SL3000 TWEETER
P/N BD0105-A

PART DESCRIPTION: SCHEMATIC, RTA 15T X-OVER		DECIMAL: 2 PLC			
DRAWING TYPE: PRODUCT	DRAWING NUMBER: P0114001	±N/A			
DRAWN BY: J.B.POLING	PART NUMBER: BE1400-A	±N/A			
DATE: 1/8/90	VIEW NUMBER: 1 of 3	Q.A. APPROVAL: <i>[Signature]</i>	DATE: 1/8/90	FRACTIONAL: ±N/A	1/24/90 (A) 18GA WAS 16GA; ADDED 1" DIMENSION
POLKAUDIO		ENGINEERING APPROVAL: <i>[Signature]</i>	DATE: 1-8-90	ANGULAR: ±N/A	REVISION RECORD
				ECO NO.	WHERE USED: AM14XX-A
					DR CK

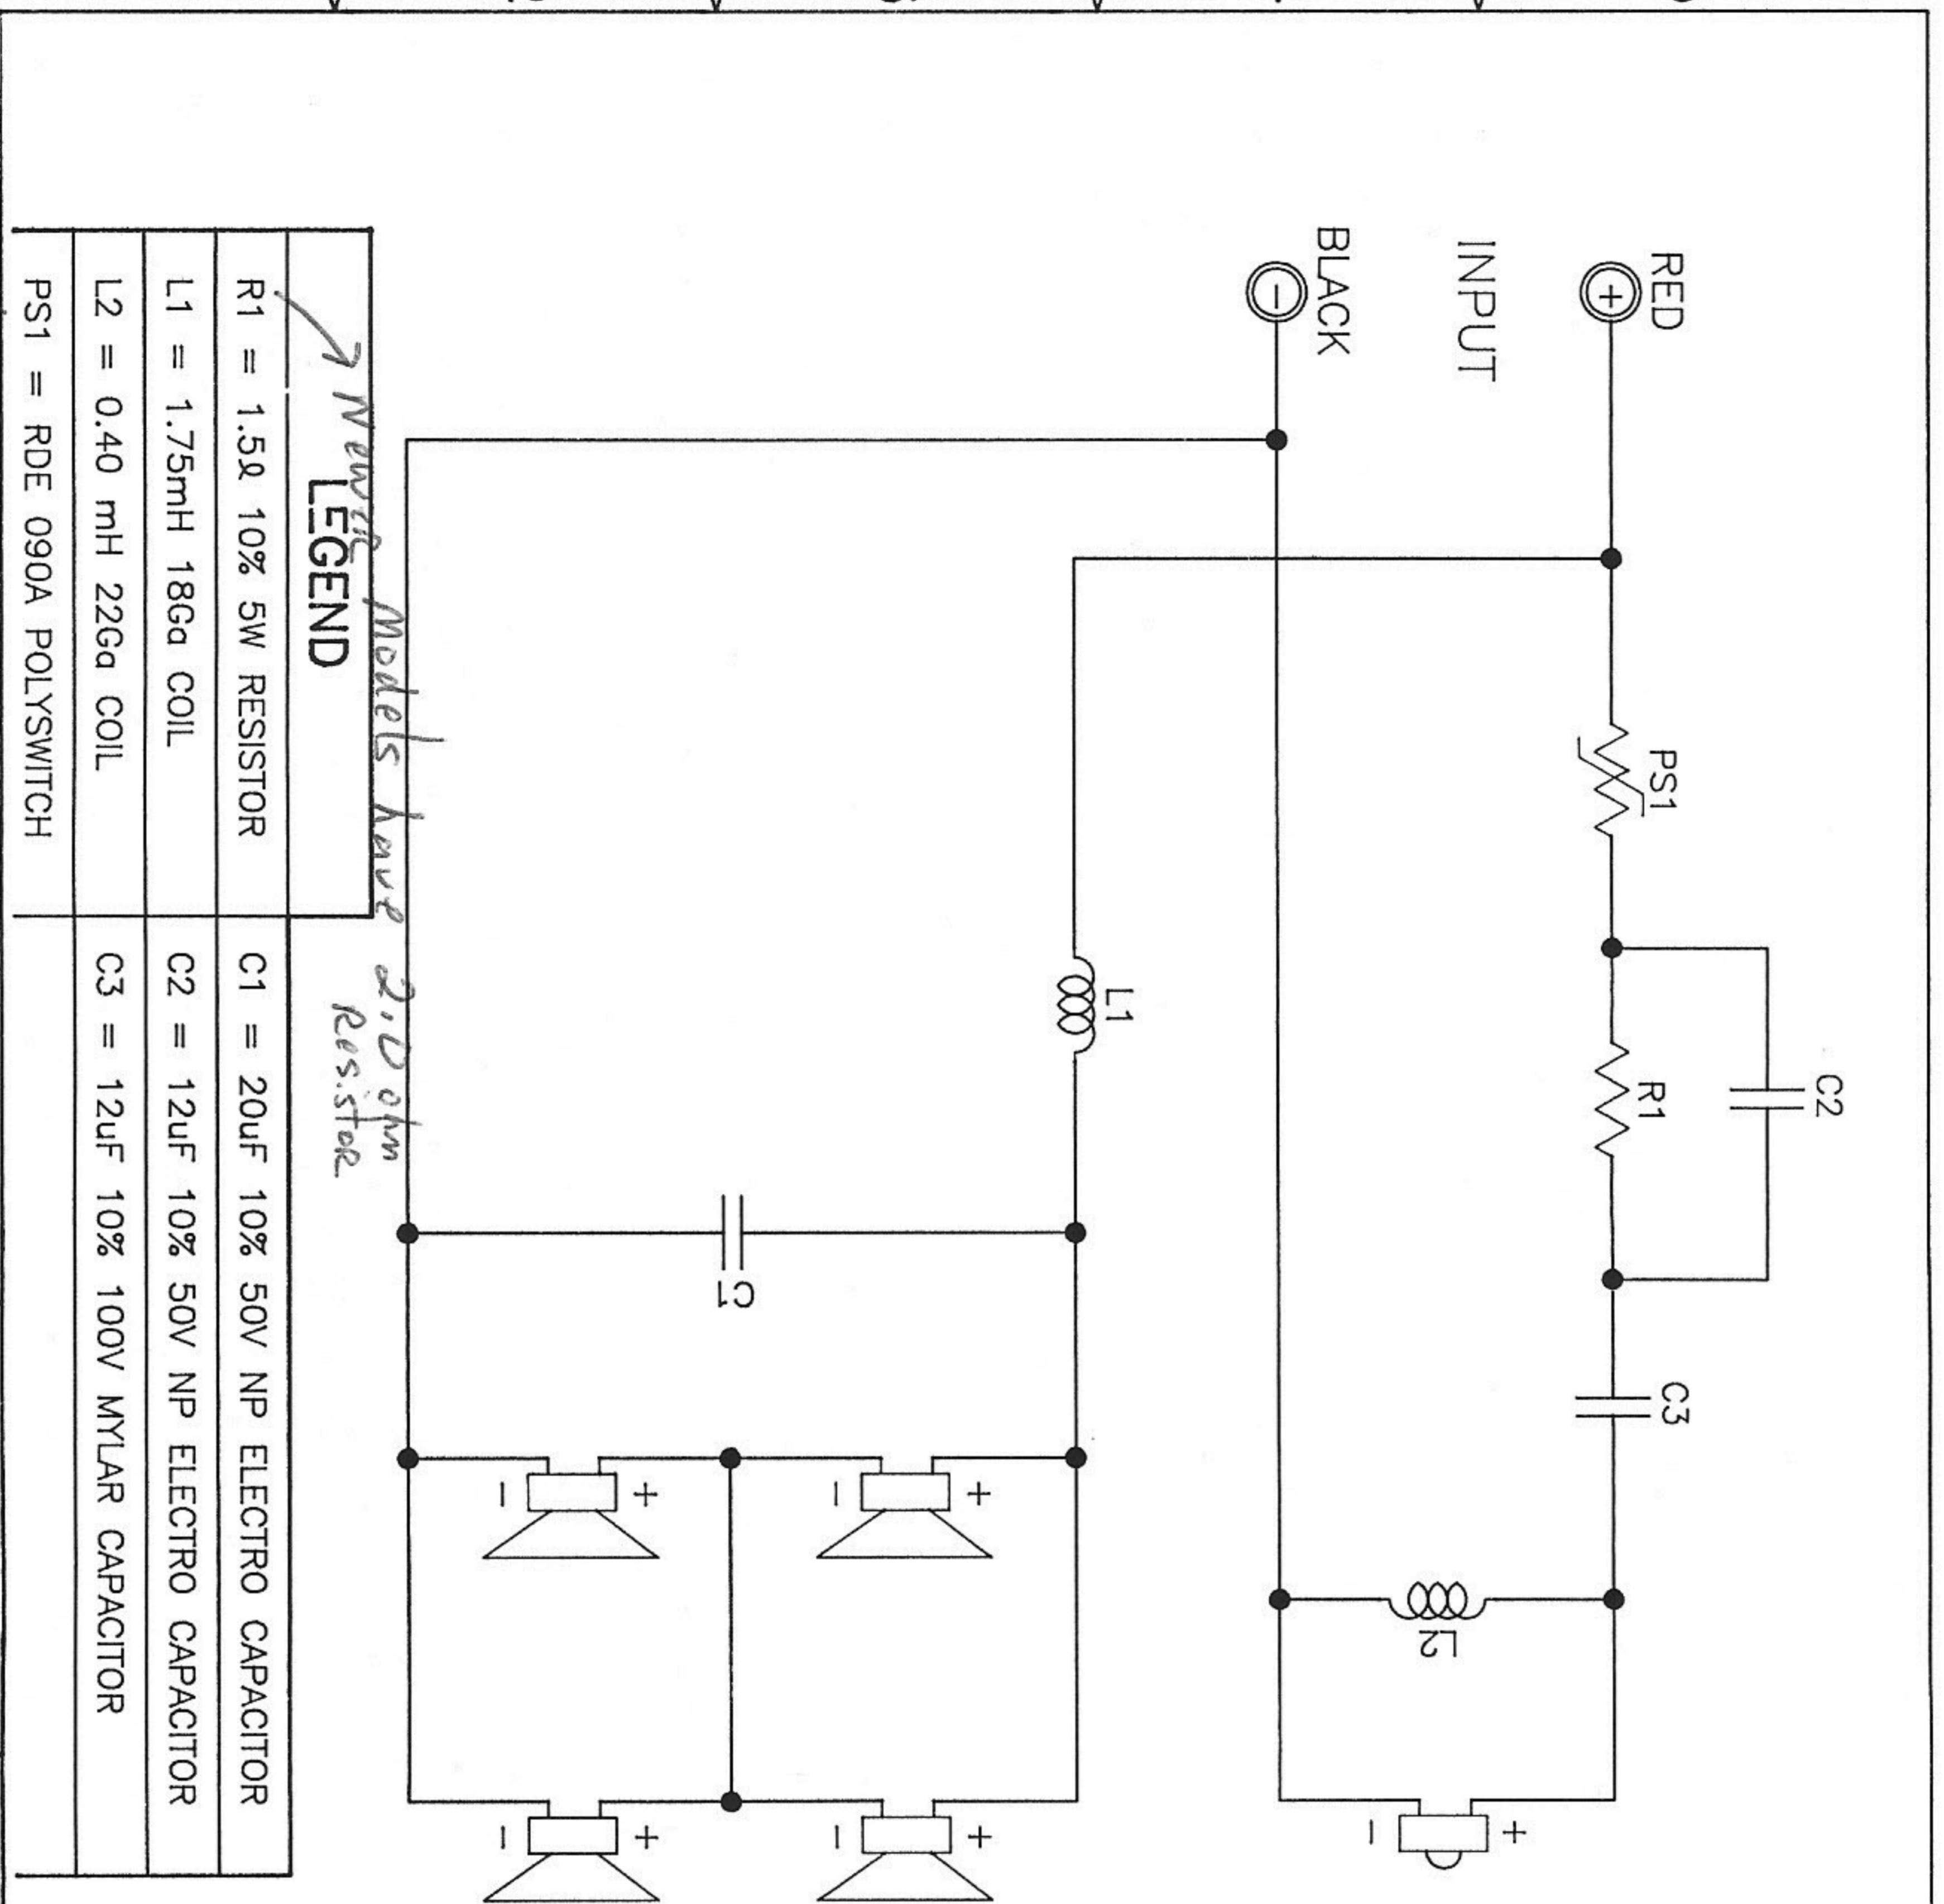
Newer Models have 2.0 ohm Resistor

Newer models have PS1 Removed
